HISTORIC AND DESIGN REVIEW COMMISSION

HDRC CASE NO: 2023-434
ADDRESS: 801 LABOR ST
LEGAL DESCRIPTION: NCB 733 BLK 5 LOT 8 & N 50 FT OF 7 ARB A8
ZONING: RM-4, H
CITY COUNCIL DIST.: 1
DISTRICT: Lavaca Historic District
APPLICANT: Michelle Hipps-Cruz/LIMINAL Design Studio
OWNER: LOCKE-MACIAS CHRISTINA ANN & RODOLFO MACIAS
TYPE OF WORK: Construction of a rear accessory structure
APPLICATION RECEIVED: October 26, 2023
60-DAY REVIEW: December 25, 2023
CASE MANAGER: Rachel Rettaliata

The applicant is requesting a Certificate of Appropriateness to construct a 2-story, 800-square-foot rear accessory structure.

NOT FOR CONSTRUCTION	L I M I N A L	MACIAS FAMILY 801 LABOR STREET ACCESSORY DETACHED DWELLING UNIT	Revisions			SITE PLAN		
			No.	Description	Date	Project number	23-02	A 100
						Date	8.21.23	
						Drawn by	Author	
						Checked by	Checker	
						Scale 1/8" = 1'-0"

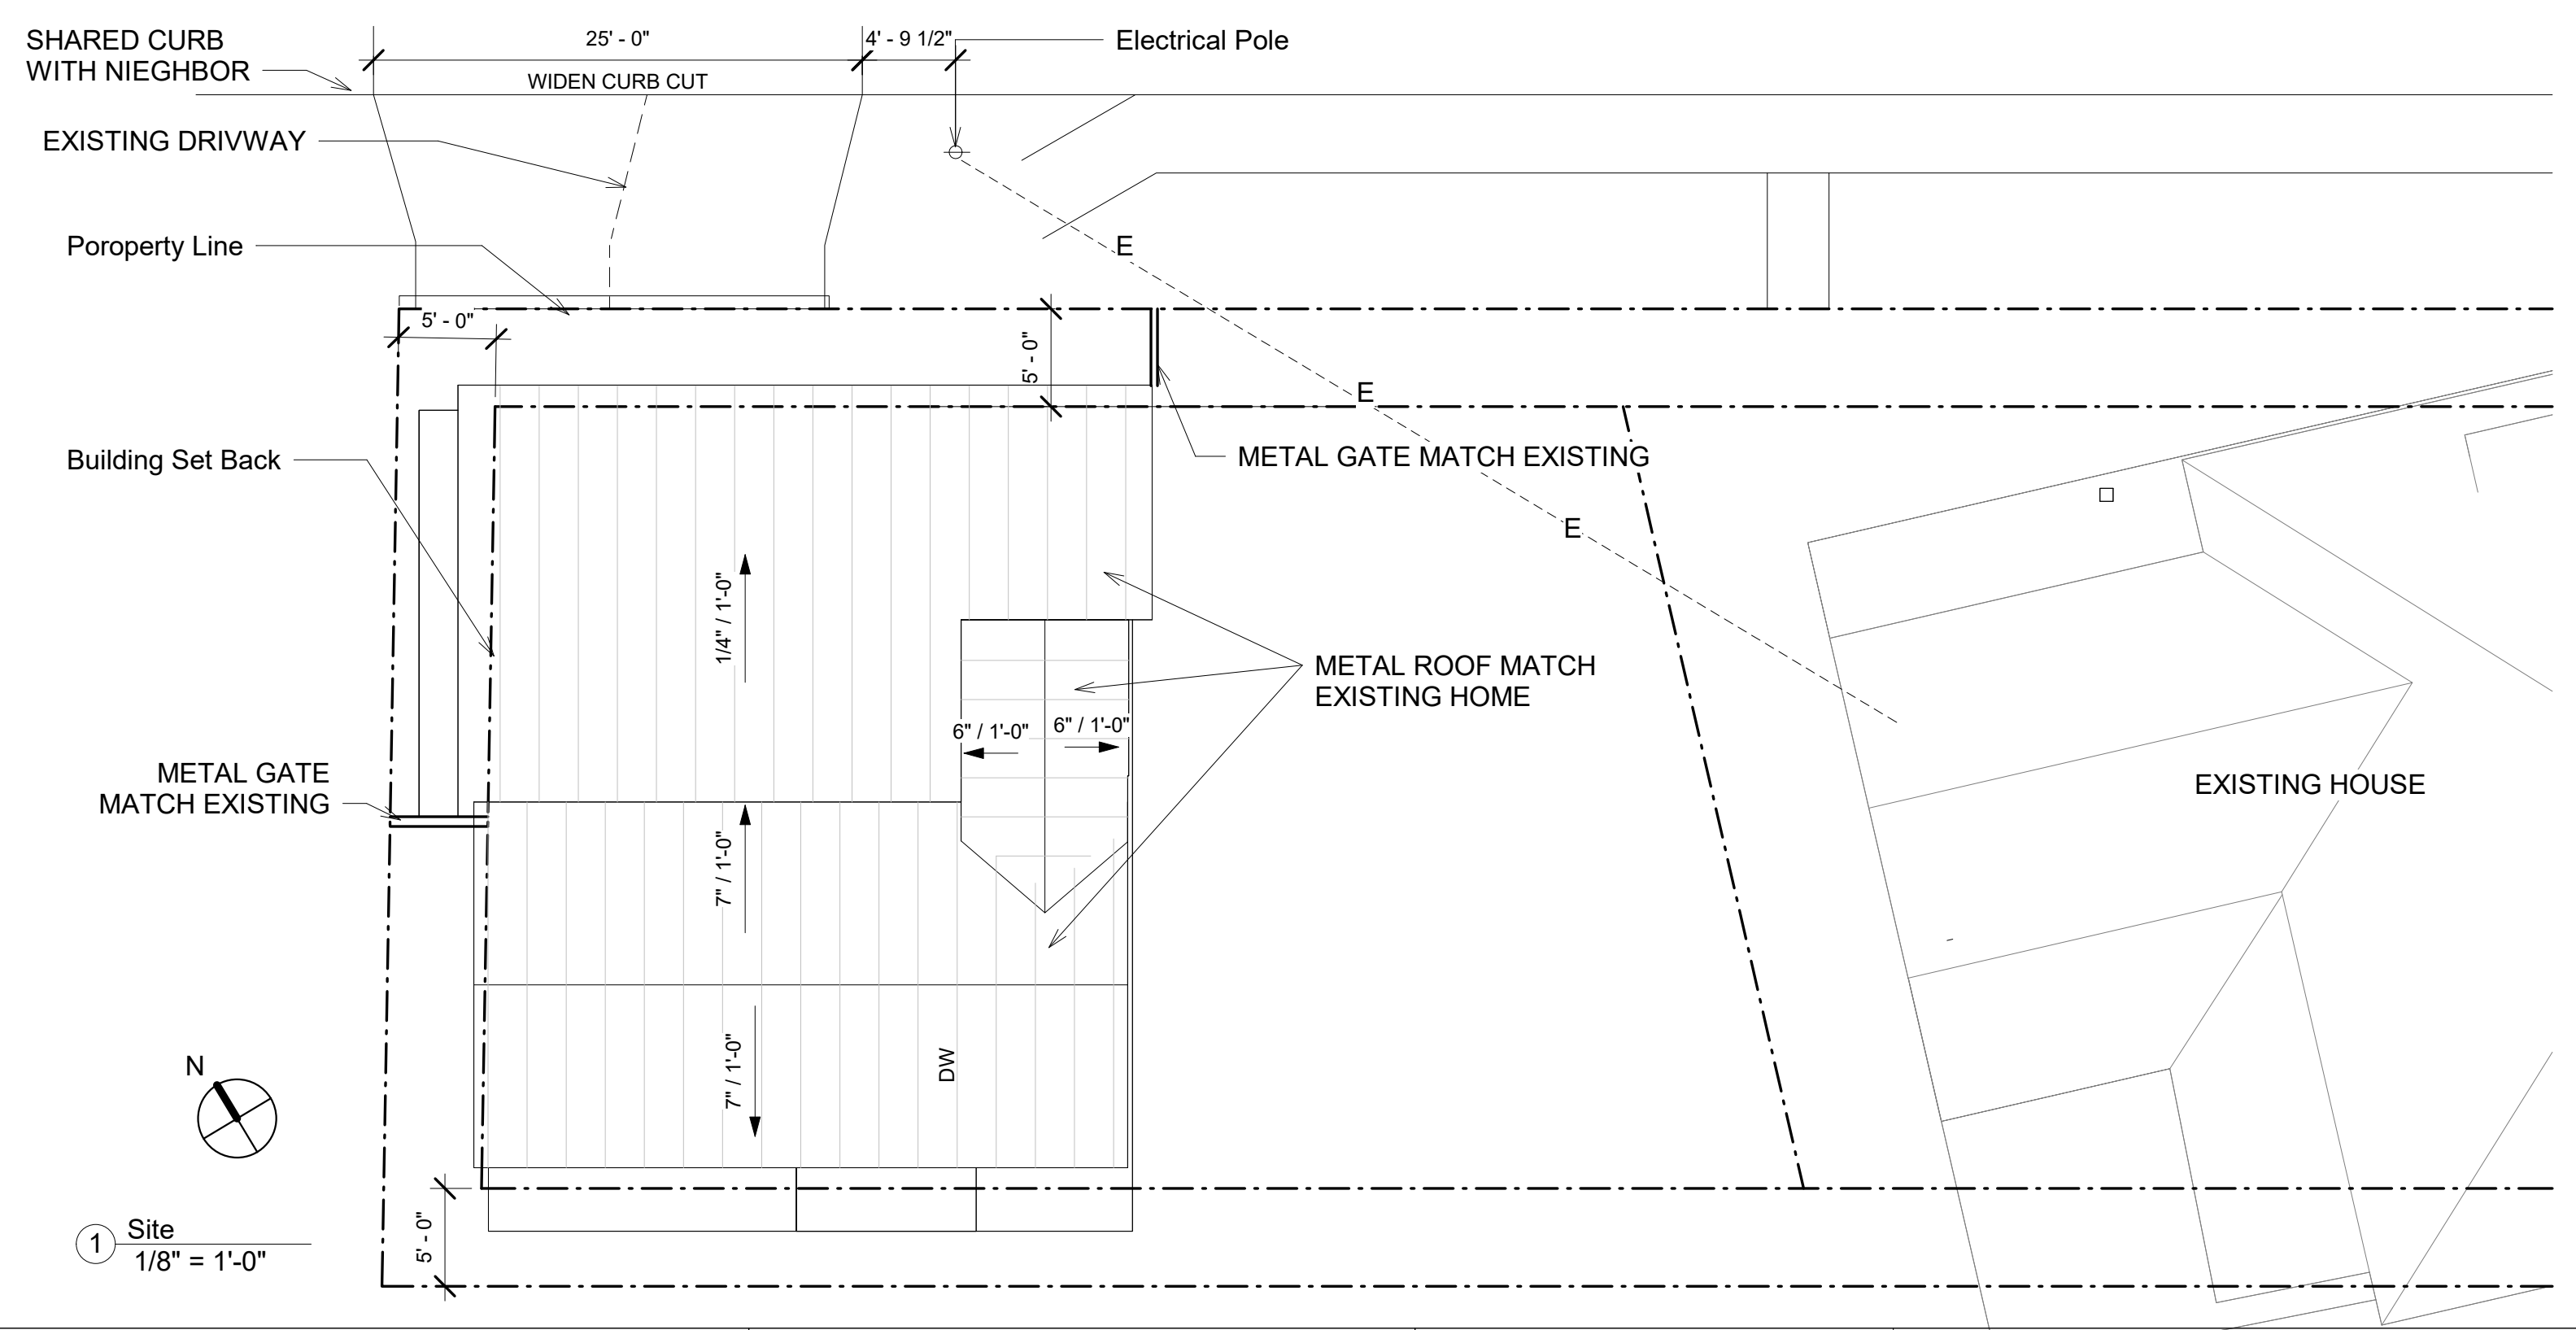
- k. DRIVEWAY MODIFICATIONS – The applicant has proposed to modify the existing driveway apron, which appears to measure 12 feet in width, to 24 feet in width and to install 5 feet of a 28-foot-wide driveway from the modified driveway apron to a new 581-square-foot concrete pad and a 518-square-foot carport. According to Guideline 5.B.i for Site Elements, historic driveway configurations should be retained and repaired in place. Applicants should incorporate a similar driveway configuration—materials, width, and design—to that historically found on the site. Historic driveways are typically no wider than 10 feet. Pervious paving surfaces may be considered where replacement is necessary to increase stormwater infiltration. Staff finds that the expansion of the existing curb cut and driveway apron is inconsistent with the Guidelines. The applicant should retain the existing curb cut and driveway apron and should install a 5-foot-long driveway to the parking pad that does not exceed 10 feet in width.

- x. That the applicant retains the existing curb cut and driveway apron width and that the new driveway to the new parking pad does not exceed 10 feet in width. The applicant is required to submit an updated site plan to staff for review prior to the returning to the HDRC based on finding k.

NOT FOR CONSTRUCTION	L I M I N A L	MACIAS FAMILY 801 LABOR STREET ACCESSORY DETACHED DWELLING UNIT	Revisions			EAST ELEVATION	
			No.	Description	Date	Project number 23-02	A 303
						Date 8.21.23	
						Drawn by Author	
						Checked by Checker	
						Scale 1/4" = 1'-0"

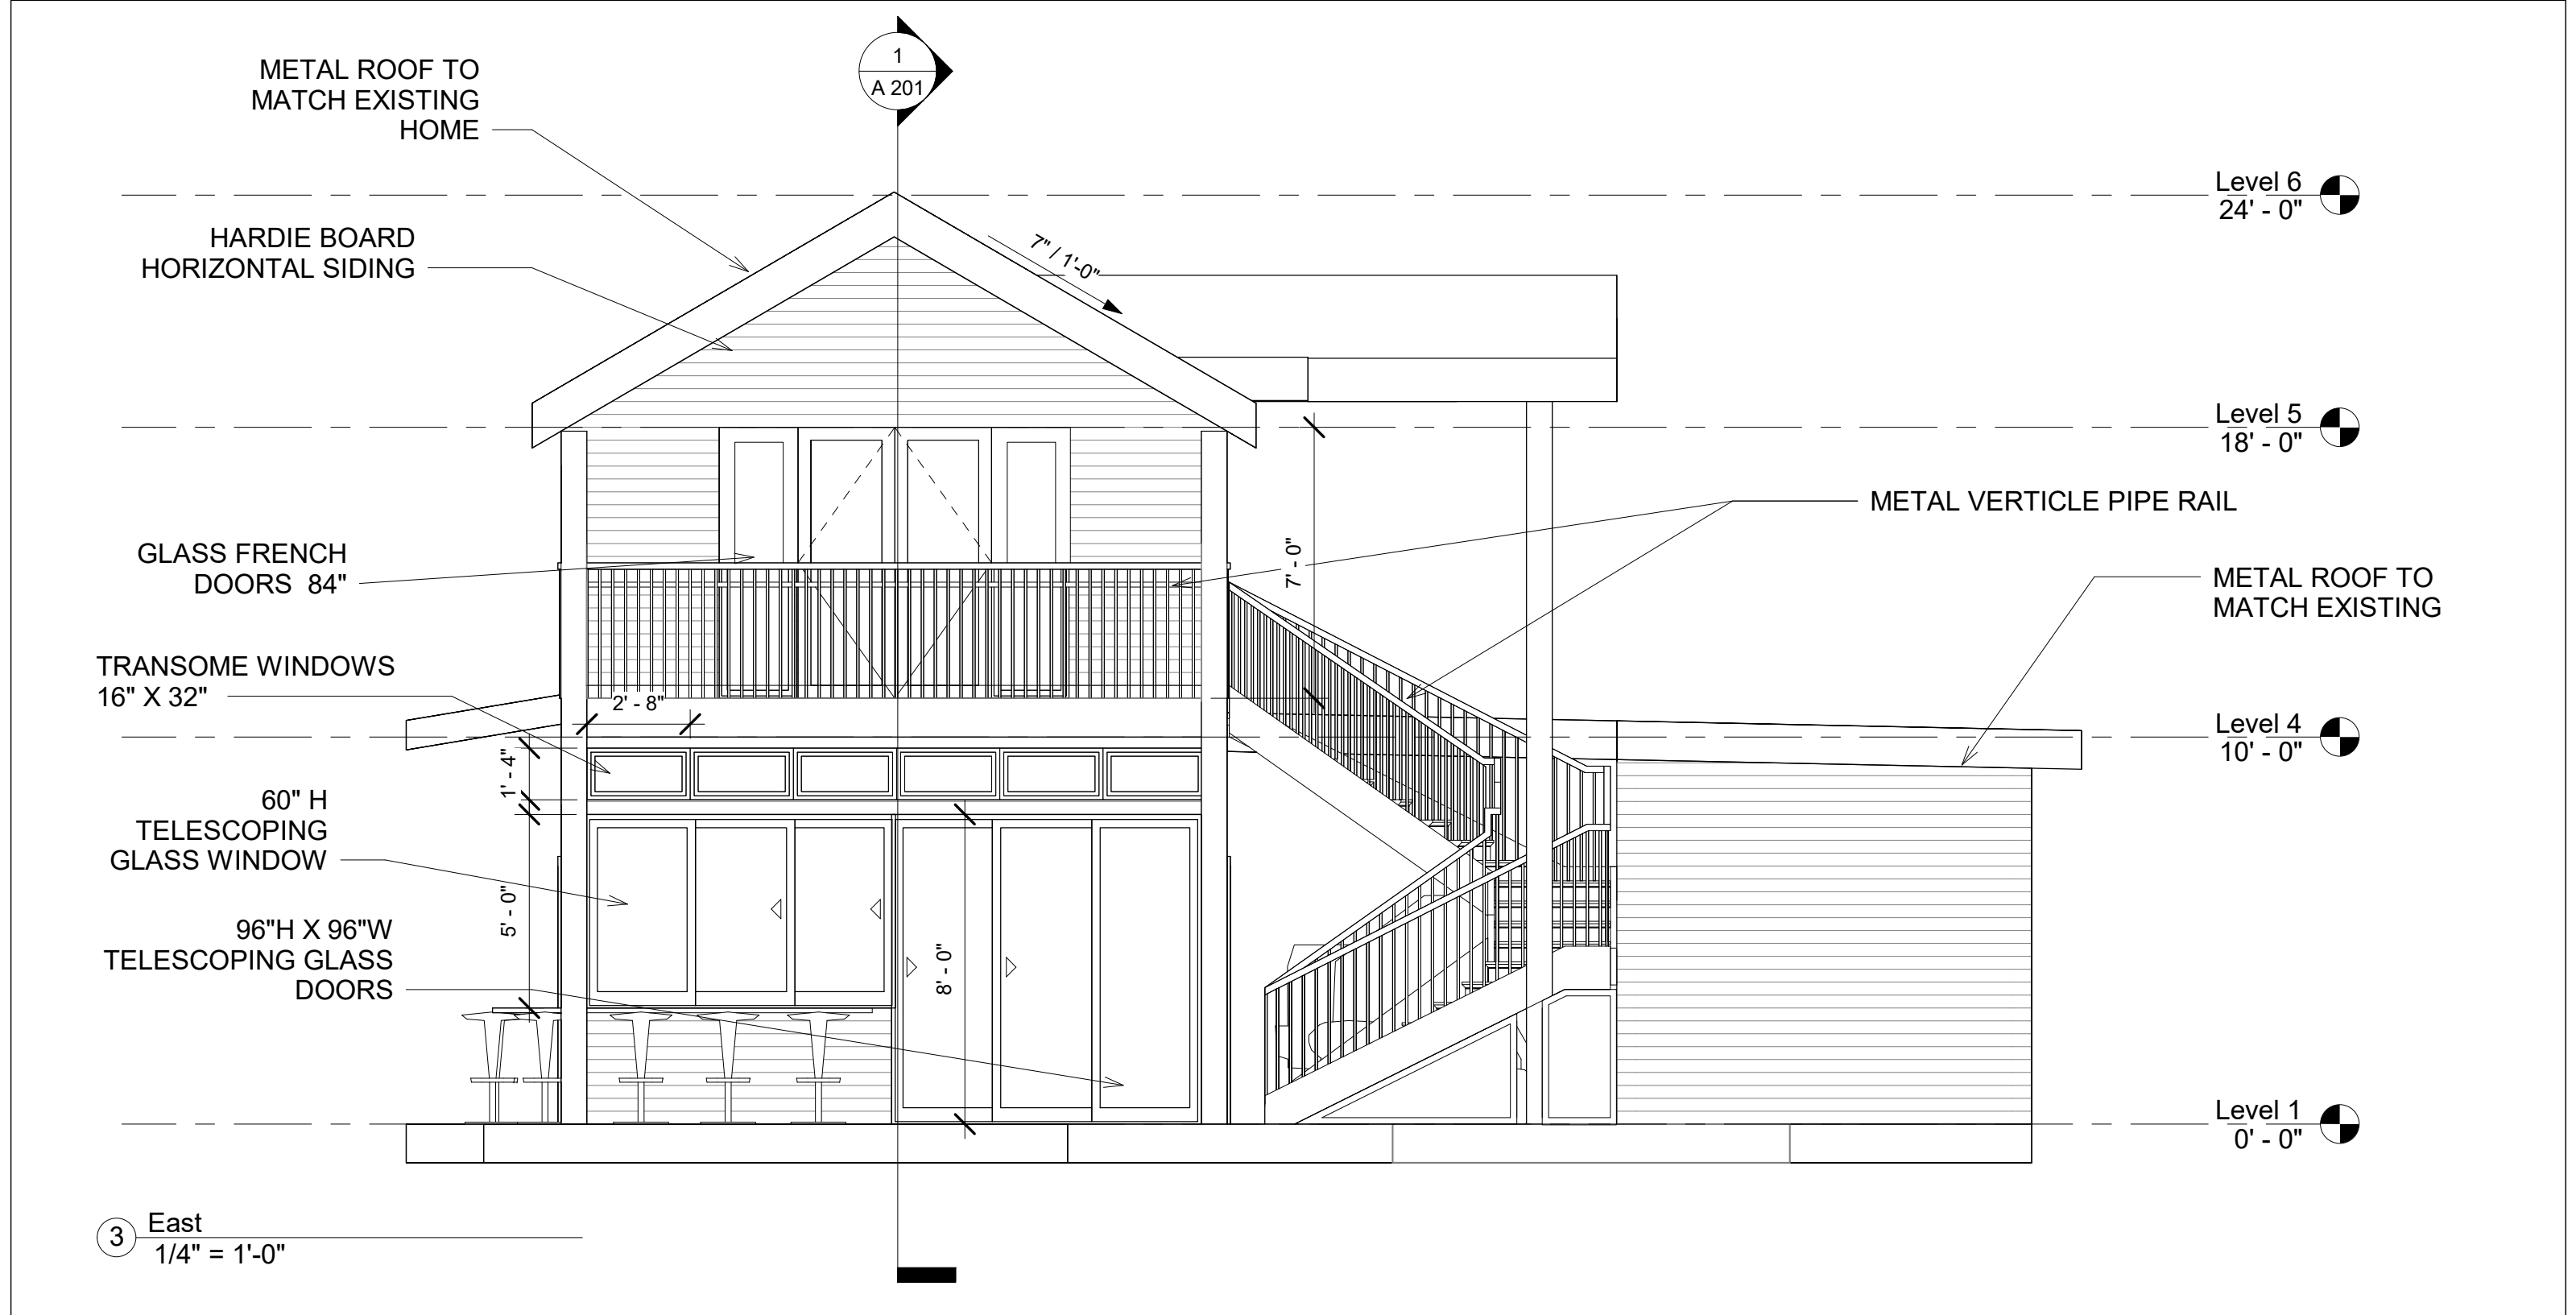
- h. NEW CONSTRUCTION: DOOR OPENINGS – Guideline 5.A.v for New Construction states that applicants should incorporate doors with similar proportions and materials as those traditionally found in the district. The applicant has proposed to install a telescoping glass door on the east elevation, full-lite French doors on the second story of the east elevation, double doors on the first floor of the west elevation, and a single door on the south elevation with a transom window. The applicant has not submitted material specifications at this time. Staff finds that the proposed door openings are generally appropriate.

- vii. That the applicant submits final material specifications for fully wood or aluminum-clad wood doors based on finding i to staff for review and approval prior to returning to the HDRC.

NOT FOR CONSTRUCTION	L I M I N A L	MACIAS FAMILY 801 LABOR STREET ACCESSORY DETACHED DWELLING UNIT	Revisions			WEST ELEVATION	
			No.	Description	Date	Project number 23-02	A 304
						Date 8.21.23	
						Drawn by Author	
						Checked by Checker	Scale 1/4" = 1'-0"

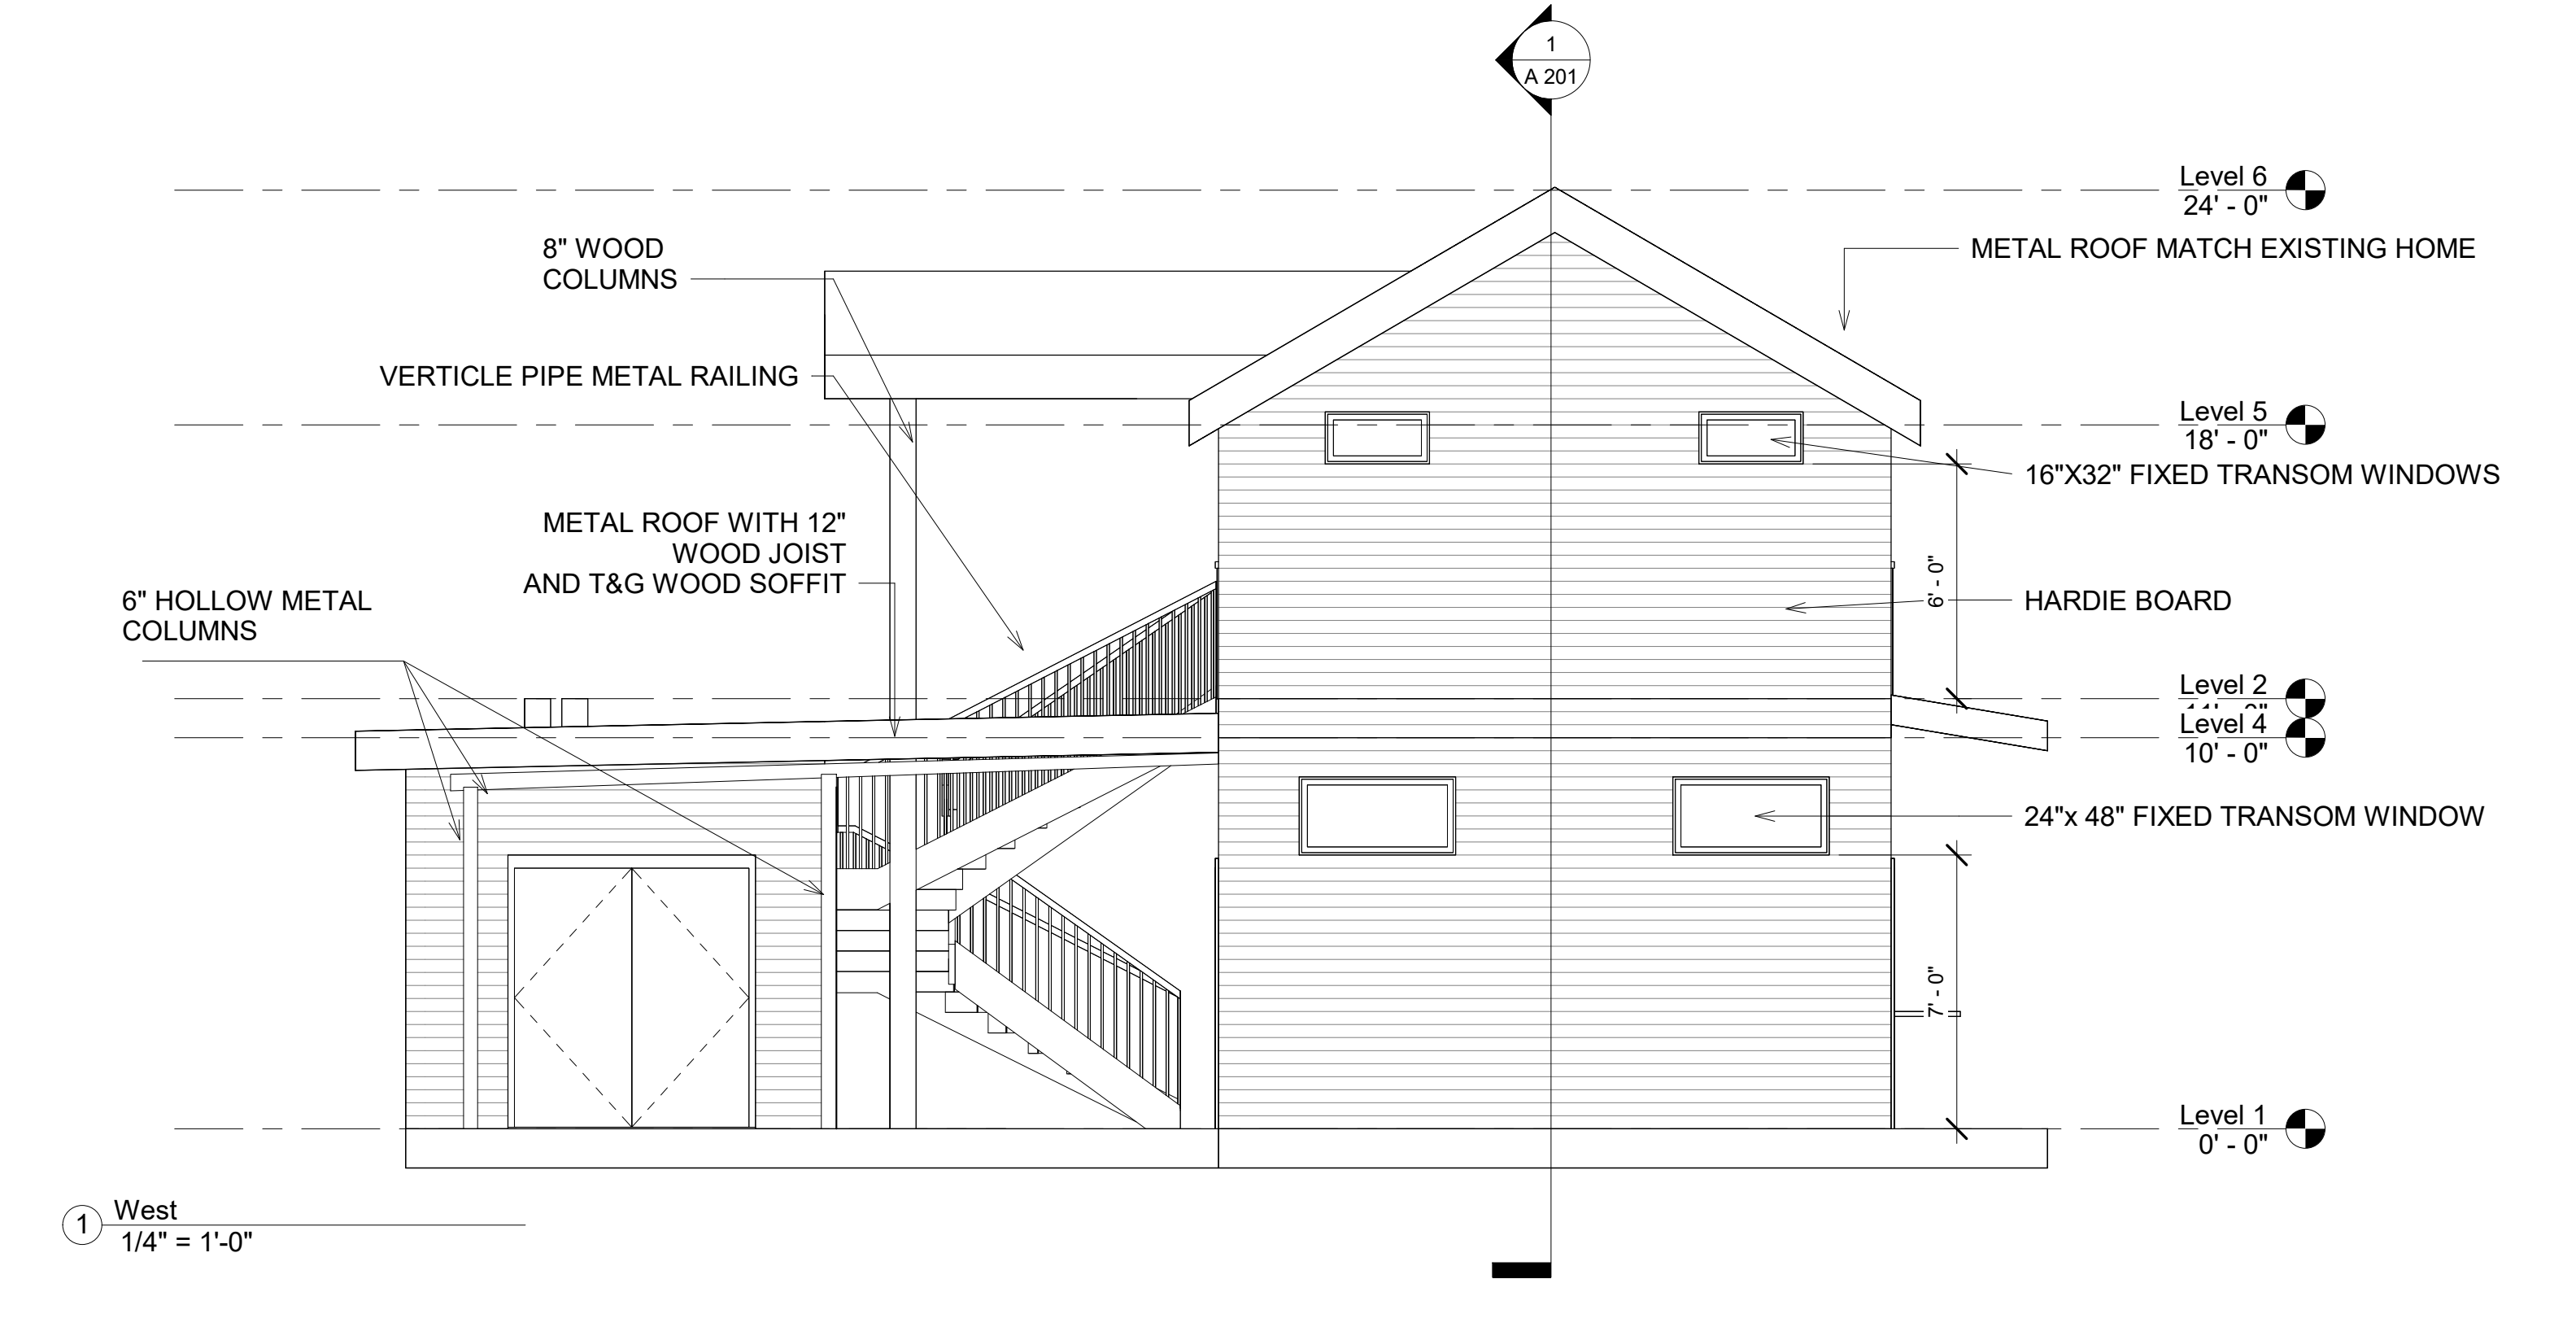
- g. NEW CONSTRUCTION: WINDOW OPENINGS – Per the Guidelines for New Construction 2.C.i., window and door openings with similar proportions of wall to window space as typical with nearby historic facades should be incorporated into new construction. The applicant has proposed to install one-over-one windows of traditional proportions, fixed transom windows on the west elevation, and a telescoping glass window on the first floor of the south and east elevations, and a row of transom windows above the east elevation. Staff finds that the applicant should propose a fenestration pattern on the west elevation that features traditional window proportions that are more in keeping with the Guidelines.

- iv. That the applicant proposes window sizes, patterns, proportions, operations and trim and sill detailing on the west elevation that are consistent with the Guidelines and historic precedents in the district as noted in finding g and submits updated elevation drawings to staff for review and approval prior to returning to the HDRC based on finding g.
